DESCRIPTION OF REQUEST: Final Sign-off for EPC Approved Site Development Plan for Subdivision

**RE: JEFFERSON & OSUNA
SITE DEVELOPMENT PLAN FOR SUBDIVISION
CONDITIONS OF APPROVAL-15 EPC-40021**

Project# 1005517
15EPC-40021 Site Plan for Subdivision

Condition 7B

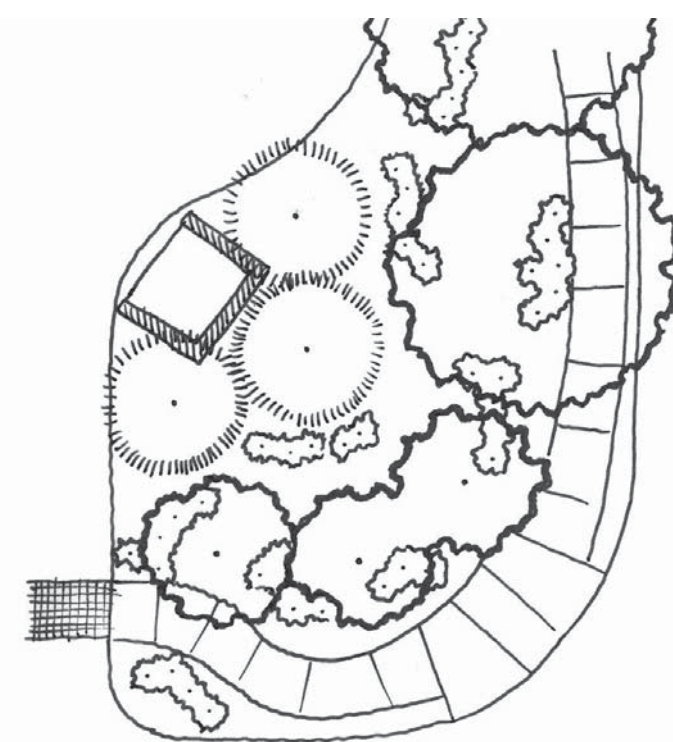
- B. On the Design Standards Sheet in the section entitled "Screening, Fencing and Walls" delete "Public Utility Structures" and insert the following language as an additional bullet:
"Screening should be designed to allow for access to utility facilities. All screening and vegetation surrounding ground-mounted transformers and utility pads are to allow 10 feet of clearance in front of the equipment door and 5-6 feet of clearance on the remaining three sides for safe operation, maintenance and repair purposes. Refer to the PNM Electric Service Guide at www.pnm.com for specifications."

This note was added to the Design Standards (see attached redlines).

m. Screening shall be designed to allow for access to utility facilities. All screening and vegetation surrounding ground-mounted transformers and utility pads are to allow 10 feet of clearance in front of the equipment door and 5-6 feet of clearance on the remaining three sides for safe operation, maintenance and repair purposes. Refer to the PNM Electrical Service Guide at www.pnm.com for specifications.
